Braddock Gateway – Phase II
Development Special Use Permit #2012-0004
Street Name Case #2012-0001

<u>Application</u>	<u>General Data</u>	
Project Braddock Gateway – Phase II Landbays II & VI	PC Hearing:	June 5, 2012
	CC Hearing:	June 16, 2012
	If approved, DSUP Expiration:	June 16, 2015
	CDD Expiration	December 31, 2027
Location: 1050, 1100, 1200A N. Fayette Street	Parcel Acreage:	
	Landbay II Landbay VI	32,887 sq ft 28,719 sq ft
Applicant: Jaguar Development LC, Represented by Mary Catherine Gibbs, Hart, Calley, Gibbs & Karp. LC	Zone:	Existing: CDD #15
	Proposed Use:	Mixed Use (residential and retail)
	Gross Floor Area:	Retail: 5,200 sq ft Residential: 177,923 sq ft Total: 183,123 sq ft
	Dwelling Units:	185 studio, one and two bedroom units
	Small Area Plan:	Braddock Metro Neighborhood Plan
	Green Building:	Compliance with the City's Green Building Policy - LEED Certification

DSUP# 2012-0004
SUB# 2012-0002
CDD CONCEPT PLAN# 2012-0002
STREET NAME CASE# 2012-0001

Emergency Vehicle Easements

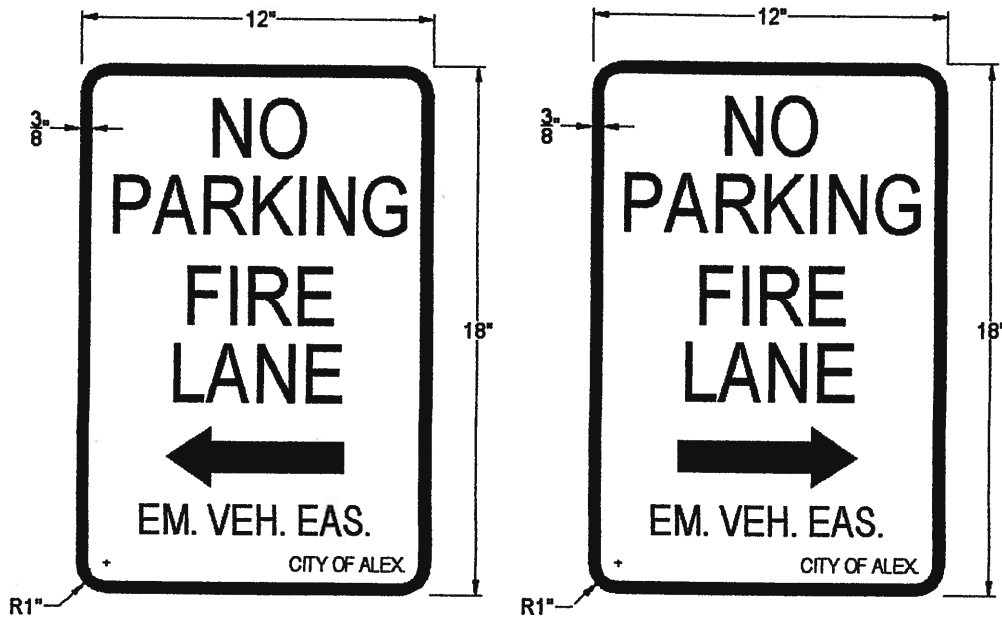
C - 7 The final site plans shall show placement of emergency vehicle easement signs. See sign detail and placement requirements below.

In addition to the side type shown on page C12.00, the following sign types shall be installed. Please revise sign designation and locations so that fire lanes are clearly marked with directional signs.

Virginia American Water Company:

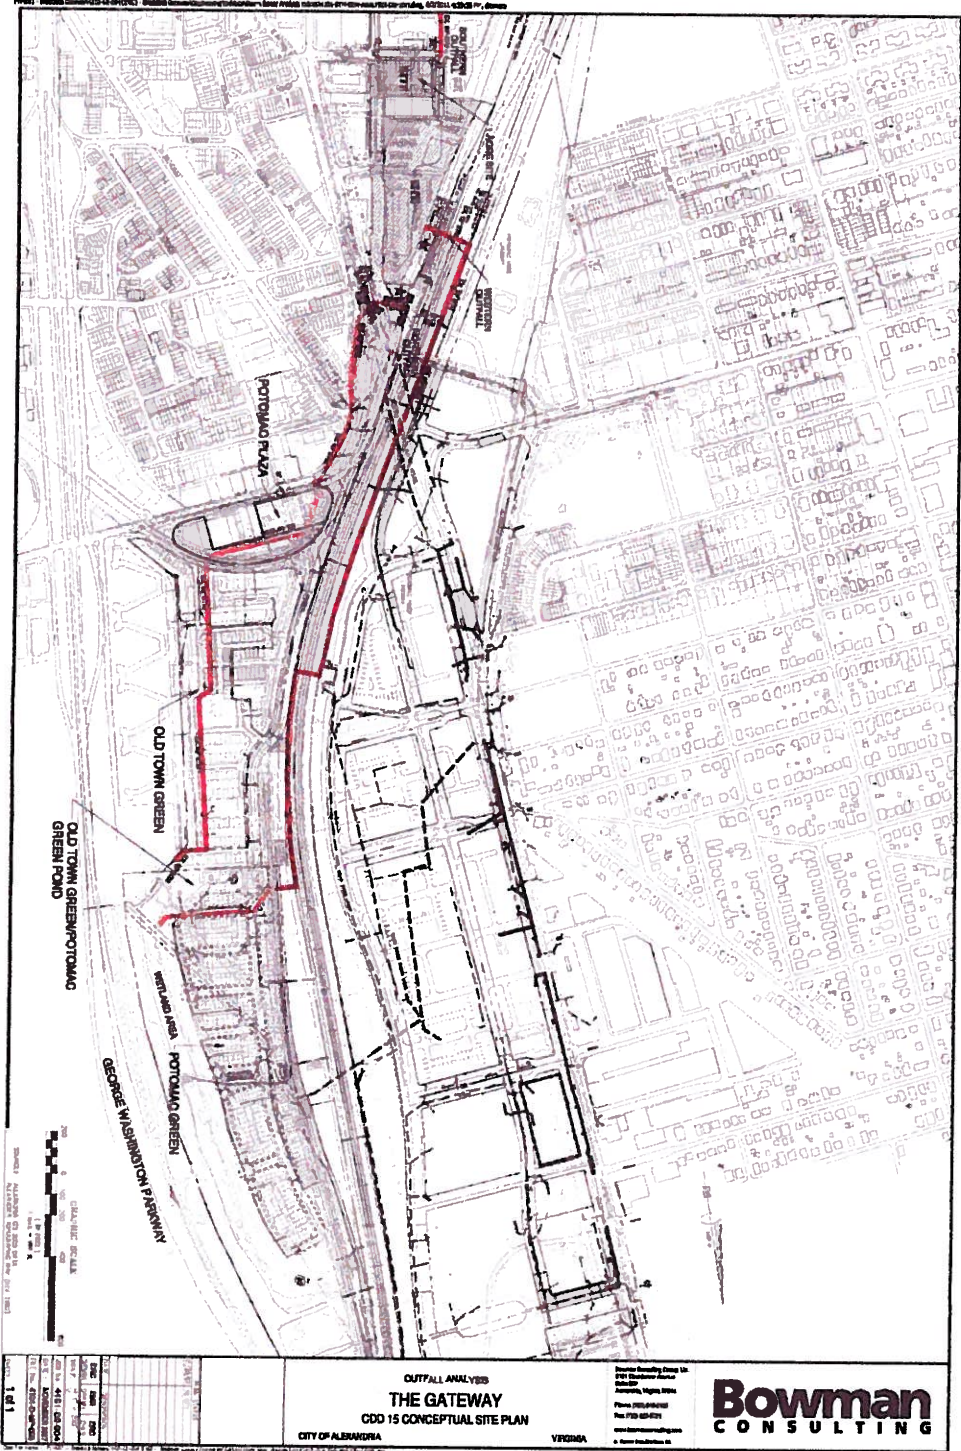
- R-1. Developer shall submit a Code Administration approved ISO calculation in order to verify whether the existing & proposed water main layouts achieve the Needed Fire Flow.

- R-2. Show the proposed fire line size and location, if the building needs a fire sprinkler system.
- R-3. Show the proposed domestic service line size.
